**SUBJECT:** NuScale Power, LLC Response to NRC Request for Additional Information No. 438 (eRAI No. 9491) on the NuScale Design Certification Application

NuScale Response to NRC Request for Additional Information eRAI No. 9491

**NRC Question No.:** 15.09-2

**Figure 15.9-2: Time Trace of Primary Coolant Flow Response to a Perturbation at 1 Percent of Rated Power and Beginning of Cycle Reactivity**

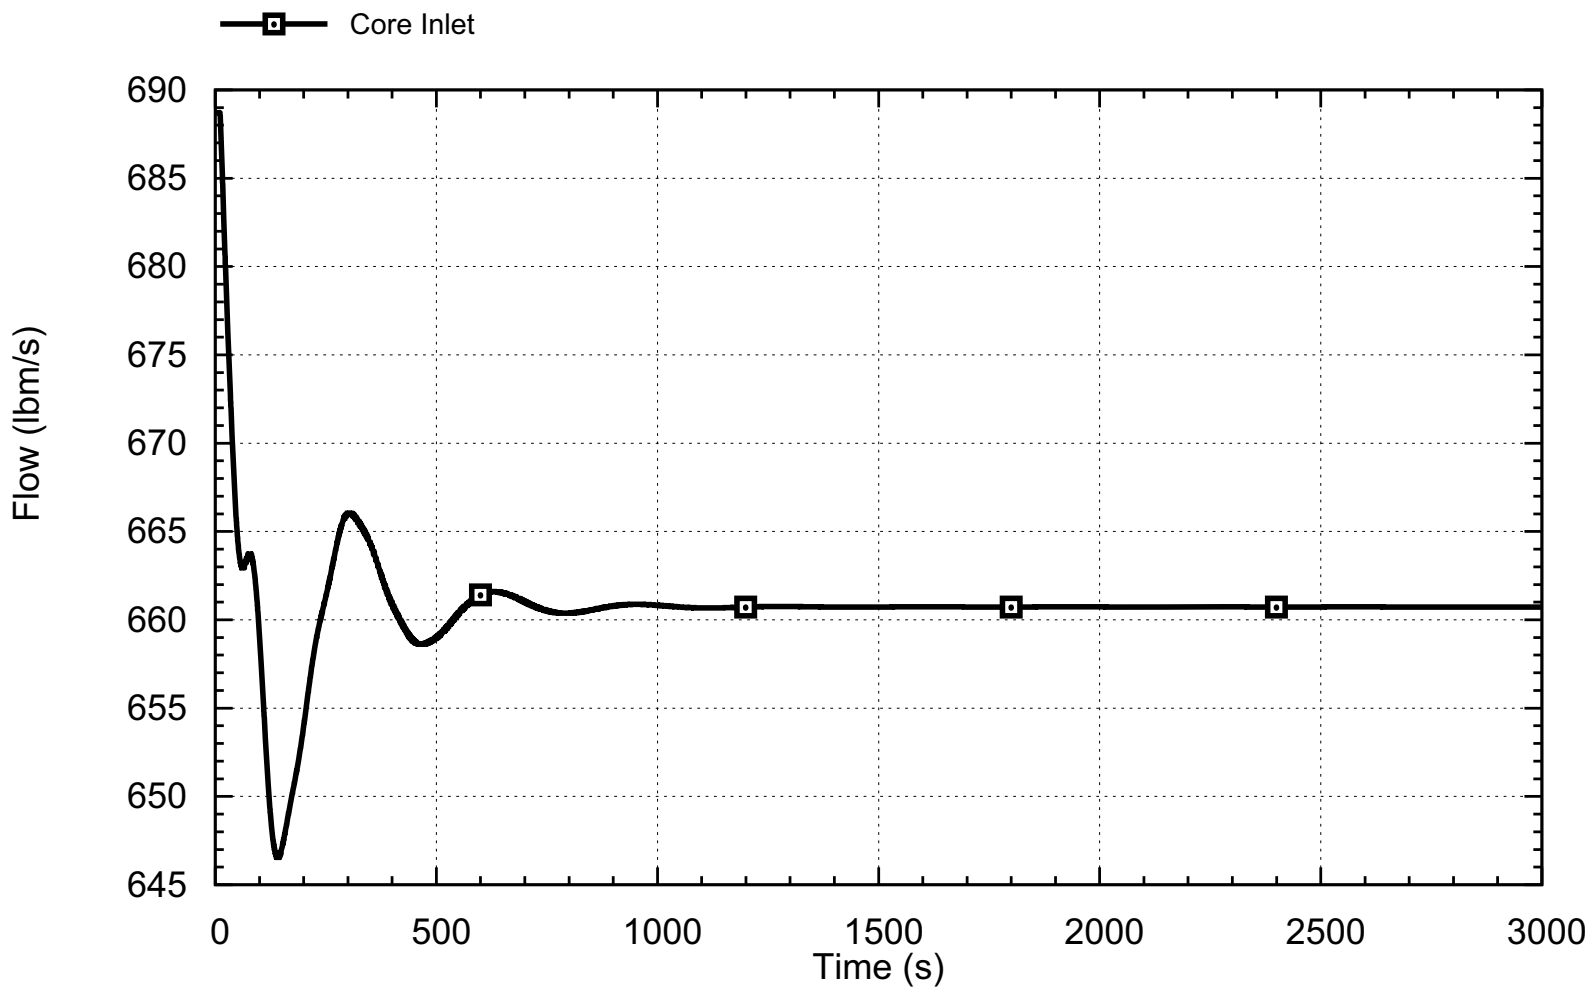
1. Provide, in the FSAR, tables of key initial conditions and parameters, their values, and their biases, that were applied to the limiting events for a given event category. Initial condition and parameter tables similar to those provided for AOO events in sections 15.1 and 15.2 of the FSAR are acceptable to staff. Examples include: Tables 15.1-2 – through 15.1-4, or Tables 15.2-1 through 15.2-3, of the FSAR. Initial values of amplitude and frequency (or period) should be included in key initial condition parameter tables for stability events where external oscillations are imposed on the reactor system model.
  2. Provide, in the FSAR, tables containing acceptance criteria values for limiting stability events. The tables should include decay ratios.
-

The analysis that produced the most limiting results is described in Table 15.9-4 and in Figure 15.9-2 and Figure 15.9-3.
